NATIONAL FIRE PROTECTION ASSOCIATION

TO: Technical Committee on Electrical Safety in the Workplace

SUBJECT: NFPA 70E First Draft TC FINAL Ballot Results (A2026)

Figure 90.4 Standard Arrangement.

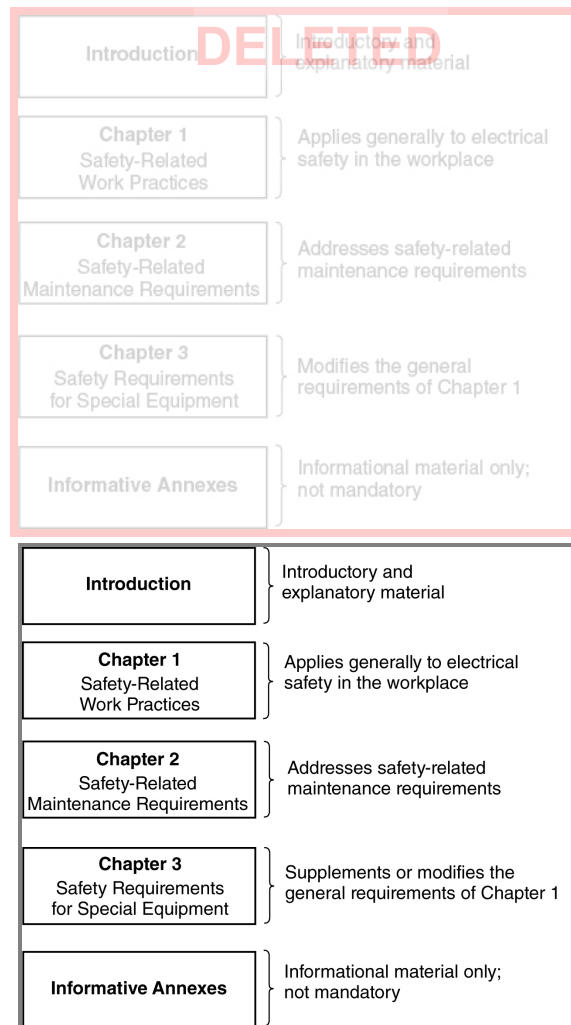
Committee Statement: The text in the Chapter 3 row of Figure 90.4 is modified to align with the provisions in Section 90.4 for correlation and clarity.

Figure J.2 Energized Electrical Work Permit Flow Chart.

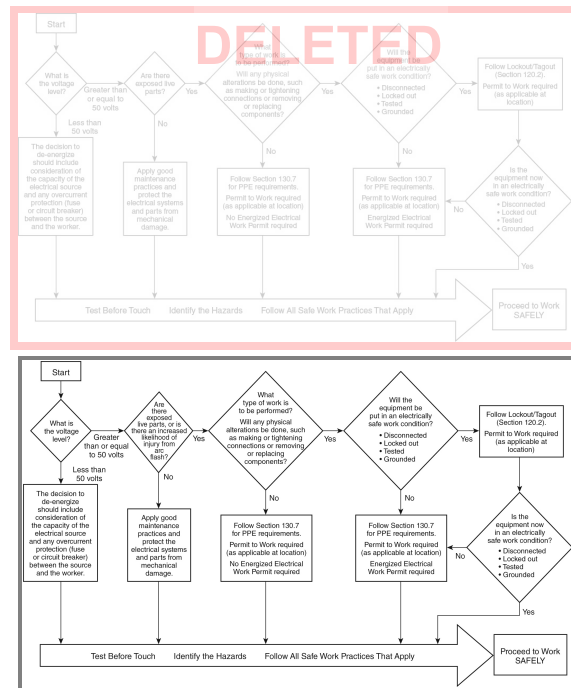
First Revision No. 73-NFPA 70E-2024 [Section No. J.2]
